# Access Compliance Report

## Public Rights-of-Way

### (Curb Ramps)

Intersection ID: N/A	Main Street: PROVIDENCE_RD	Cross Street: N/A	Location: S
ADA ID: 2C0A19209591	Ramp Type: Perp	Initial Pass/Fail: Fail	Overall Compliance: No
Severity Score: 10			
Codes/Mitigation Info/Possible Solution		Field Measurements/Component Compliance

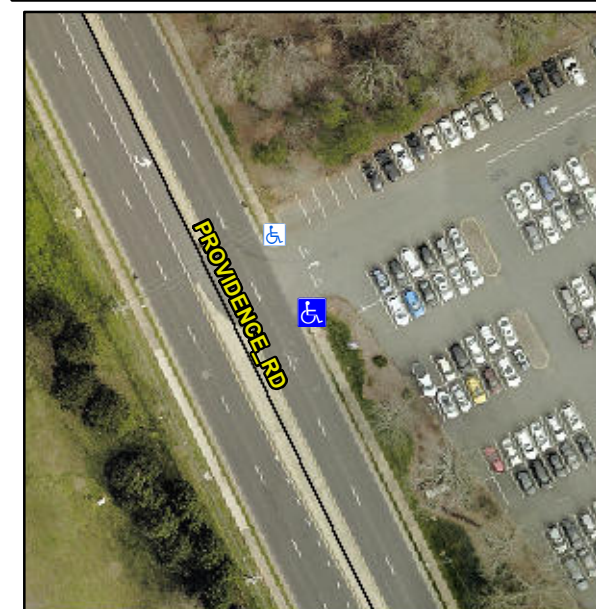
**Not Found, R304.5.1, R304.5.3**

Compliance	Description	Data	Compliance	Description	Data
N/A	Ramp Length (in)	83.0	Yes	Ramp Slope (%)	7.3
No	Ramp Width (in)	47.0	No	Ramp XSlope (%)	2.9
N/A	Flare Type LT	N/A	N/A	Flare Type RT	N/A
N/A	Flare Slope LT (%)	N/A	N/A	Flare Slope RT (%)	N/A
N/A	Flare Traversable LT?	N/A	N/A	Flare Traversable RT?	N/A
N/A	Landing Length (in)	N/A	N/A	DWS Provided?	N/A
N/A	Landing Width (in)	N/A	N/A	DWS Contrast?	N/A
N/A	Landing Slope (%)	N/A	N/A	DWS Length (in)	N/A
N/A	Landing X Slope (%)	N/A	N/A	DWS Full Width?	N/A
N/A	Landing Curb? (Y/N)	N/A	N/A	DWS Offset (in)	N/A
N/A	Shared Landing?	N/A			
N/A	Gutter Ponding?	N/A	N/A	Gutter Slope (%)	N/A
N/A	Gutter Lip Ht (in)	N/A	N/A	Gutter X Slope (%)	N/A
N/A	Painted X Walk1?	No	N/A	Painted X Walk2?	N/A
	X Walk 1 Direction	To NW		X Walk 2 Direction	N/A
N/A	X Walk 1 Width (in)	N/A	N/A	X Walk 2 Width (in)	N/A
	X Walk 1 Slope (%)	3.7		X Walk 2 Slope (%)	N/A
	X Walk 1 X Slope (%)	1.6		X Walk 2 X Slope (%)	N/A

**Remove & Replace Entire Ramp.**
